**TO:** All Bidders under **ITB 23-101610, NH Scott Pool Renovations**

**ADDENDUM NO. # 1**

**ITB 23-101610, NH Scott Pool Renovation**, is hereby amended as follows:

**AQ0.0**

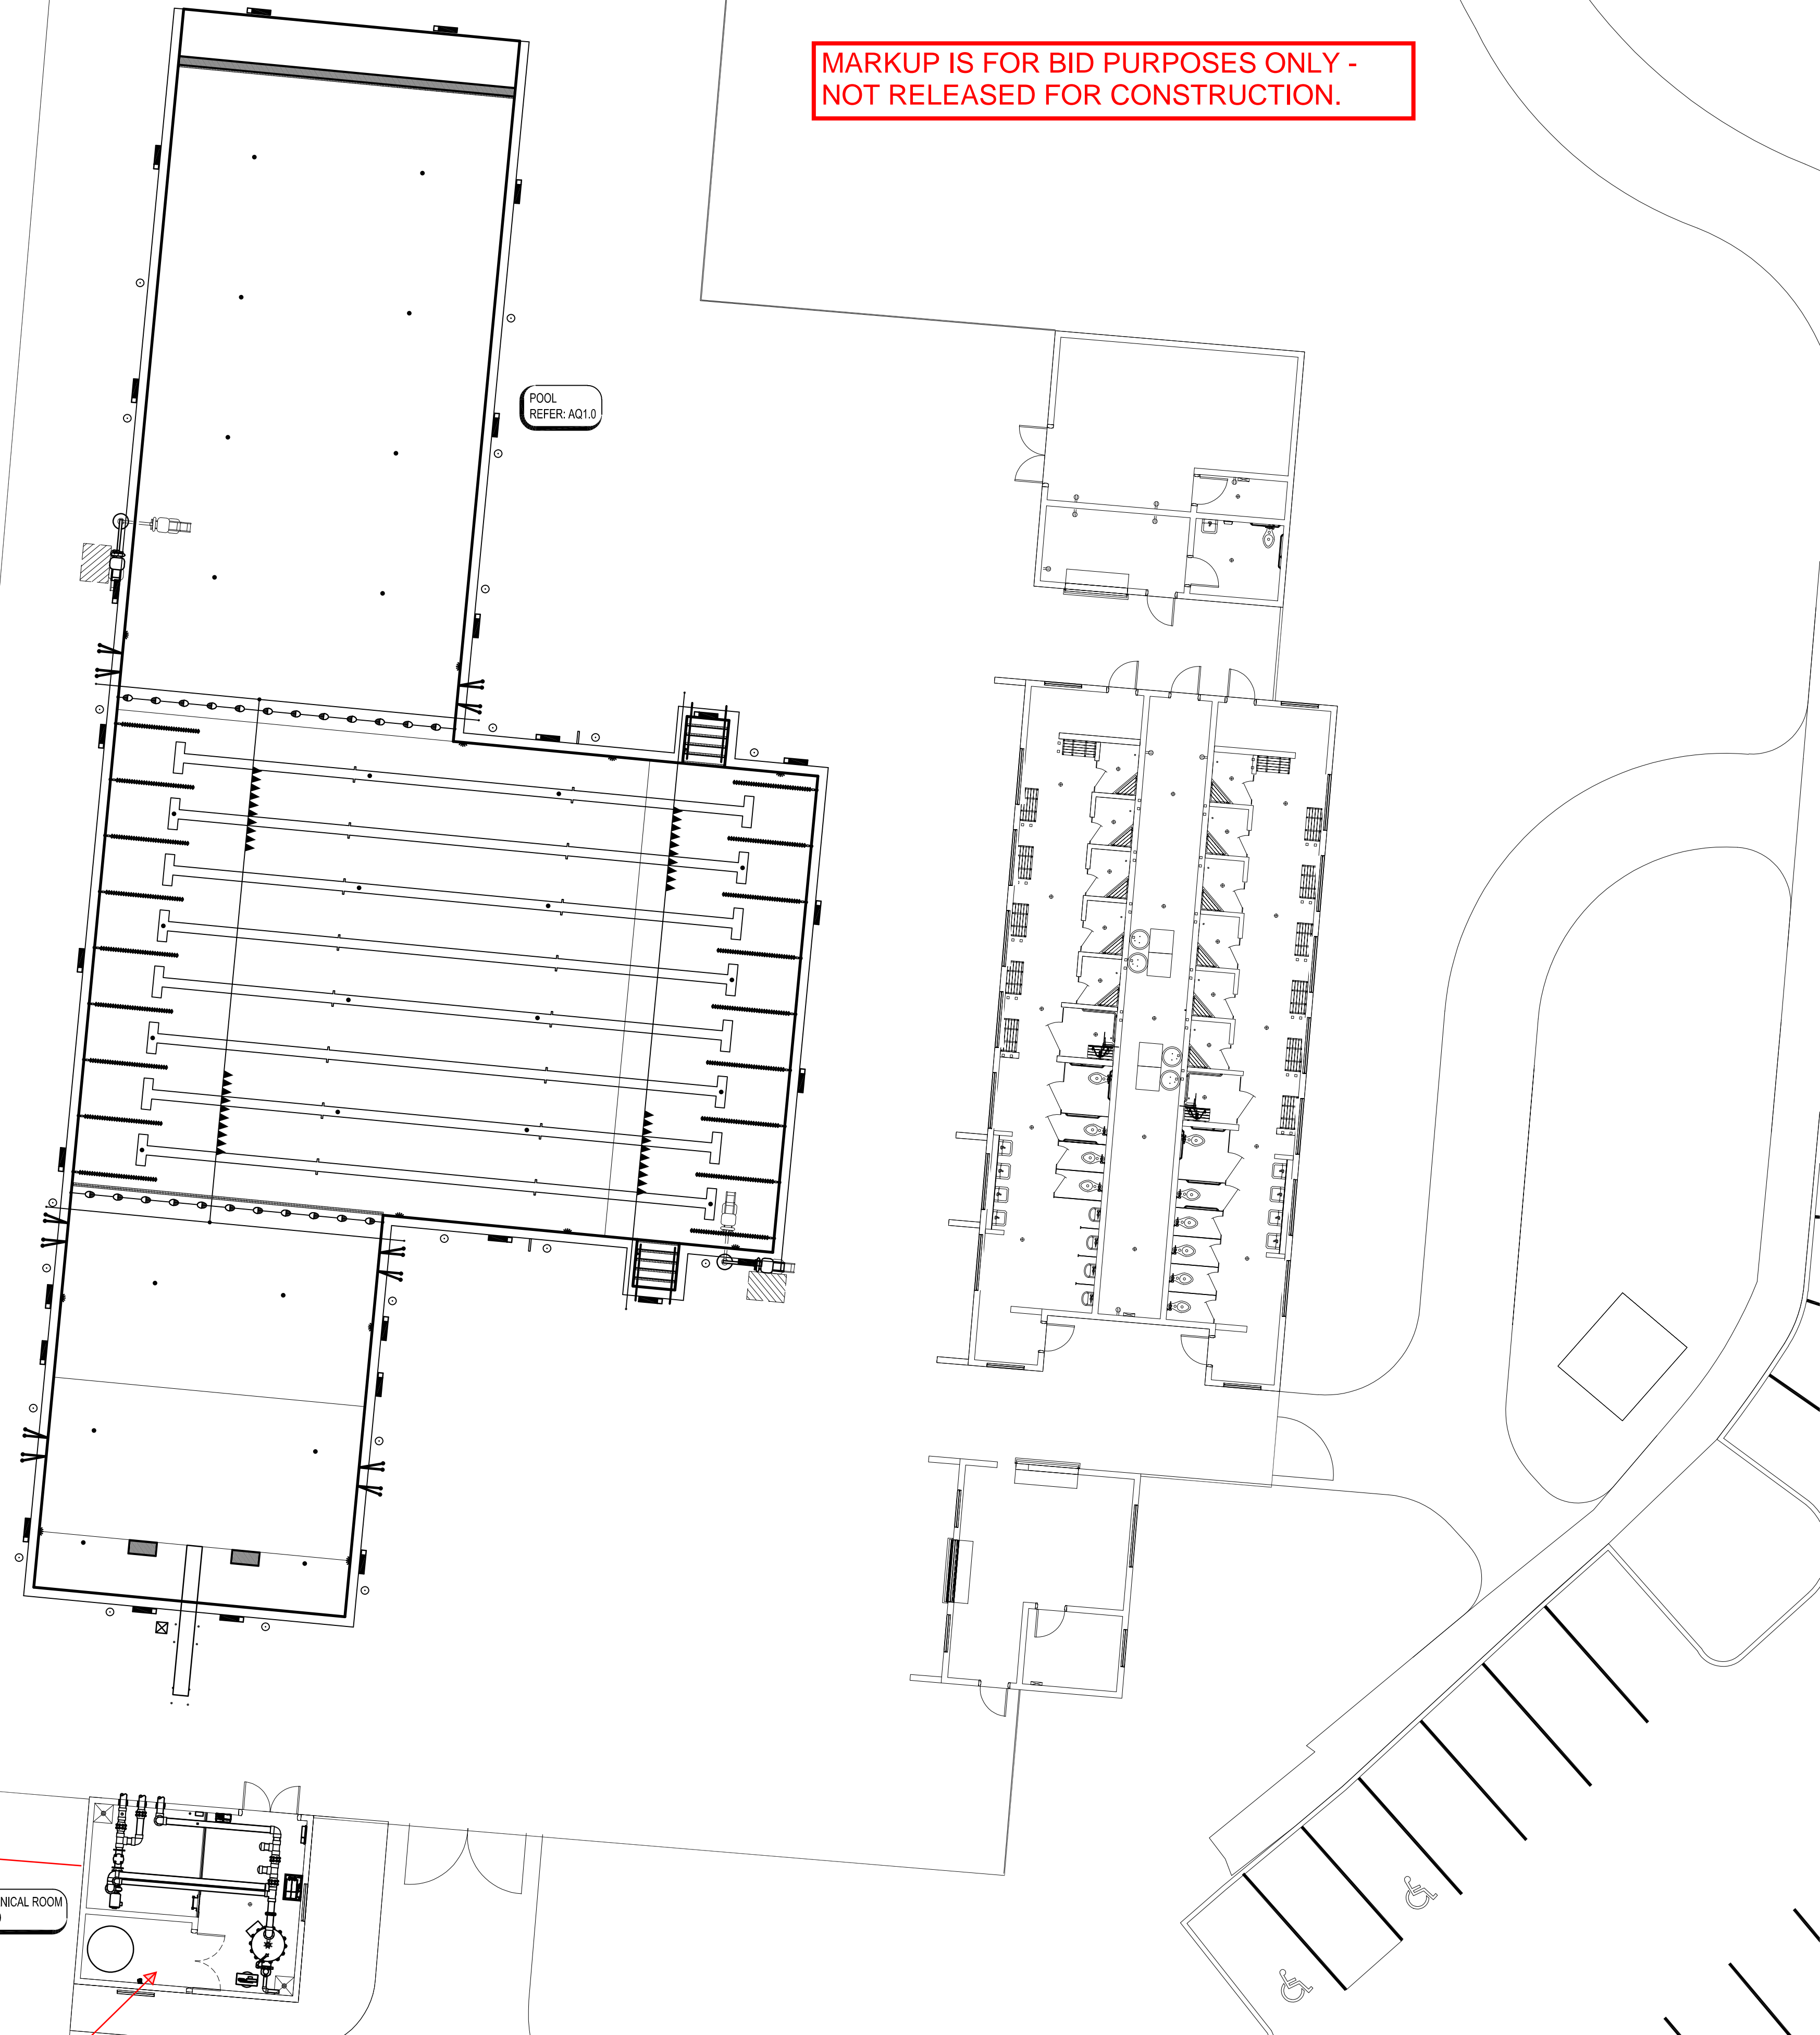
3. We have received questions pertaining to this Invitation To Bid (ITB). The questions and their resulting answers appear below:
  - A. **Question:** Are there electrical siteplans for this project?

**Answer:** Yes, please refer to sheet AQ0.0, attached. A work allowance of \$260,000.00 will also be included at the owner's discretion to be utilized for coordination for the electrical work which will be in addition to the cost of installation for the electrical work as priced per the sheet AQ0.0 as part of the base bid.

PROVIDE BRANCH CIRCUITS AS REQUIRED TO FEED ALL NEW POOL MECHANICAL EQUIPMENT IN THE POOL MECHANICAL ROOM AS INDICATED IN THESE DRAWINGS. SIZE CONDUITS, CONDUCTORS AND CIRCUIT BREAKERS PER NEC MINIMUM REQUIREMENTS. MINIMUM CONDUIT SIZE IS 1/2". ALL CONDUCTORS SHALL BE COPPER. ALL PANEL BUSSES SHALL BE COPPER. PROVIDE POWER SYSTEM GROUNDING PER NEC 70, ARTICLE 250. PROVIDE COMPLETE POOL GROUND SYSTEM PER NEC REQUIREMENTS. PROVIDE GFCI RECEPTACLES WITH AN IN-USE LEXAN COVER WHERE REQUIRED BY THE NEC. PROVIDE 1'X4" SUSPENDED LED LIGHTING IN POOL MECHANICAL ROOM, MINIMUM OF FOUR. INTERIOR LIGHTING TO BE CONTROLLED BY A WALL MOUNTED INTERIOR TOGGLE SWITCH. FOR CIRCUITS LARGER THAN 100A, USE 75 DEGREE C RATED COPPER CONDUCTORS (NEC TABLE 310.15(B)(16)) TO SIZE THE CONDUCTORS. FOR CIRCUITS 100A AND LESS, USE 60 DEGREE C RATED COPPER CONDUCTORS FOR BREAKERS 100A AND LESS. (NEC TABLE 310.15(B)(16)). USE THHN/THWN CONDUCTOR INSULATION FOR CONDUIT SIZING. EQUIPMENT GROUNDING CONDUCTOR SIZE IS BASED ON CIRCUIT BREAKER SIZE AND NEC TABLE 250-122. ALL CONDUCTORS SHALL BE MANUFACTURED BY AN AMERICAN MANUFACTURER. PROVIDE ALL STARTERS AND DISCONNECTS REQUIRED FOR THE POOL MECHANICAL EQUIPMENT. PROVIDE HOUSEKEEPING PADS, MINIMUM 4" THICK AS REQUIRED.

APPROXIMATE LOCATION OF THE EXISTING UTILITY PAD MOUNTED TRANSFORMER. FIELD VERIFY EXISTING TRANSFORMER SIZE AND SECONDARY VOLTAGE PRIOR TO BID. ASSUMED SECONDARY VOLTAGE IS 480Y/277V, 3P, 4W. SEE SHEET CU101 FOR ADDITIONAL INFORMATION.

PROVIDE 4-3/0 & 1#6G-2" C FROM EXISTING PAD MOUNTED TRANSFORMER TO NEW POOL MECHANICAL BUILDING. BURY CONDUIT 30" BFG AND PROVIDE WIRE TAPE AT 12" BFG. TRENCH AND BACKFILL WITH LIKE MATERIALS. PROVIDE SCHEDULE 40 PVC CONDUIT BELOW GRADE.

PROVIDE (1) 200A, 480Y/277V, 3P, 4W, 30 POLE ELECTRICAL PANEL WITH A 200A MCB IN A NEMA 1 ENCLOSURE. MINIMUM SCCR OF 35,000A. PROVIDE (1) 30 KVA 480V:208Y/120V DRY-TYPE TRANSFORMER. PROVIDE (1) 100A, 208Y/120V, 3P, 4W, 30 POLE ELECTRICAL PANEL WITH A 100A MCB IN A NEMA 1 ENCLOSURE. MINIMUM SCCR OF 10,000A.
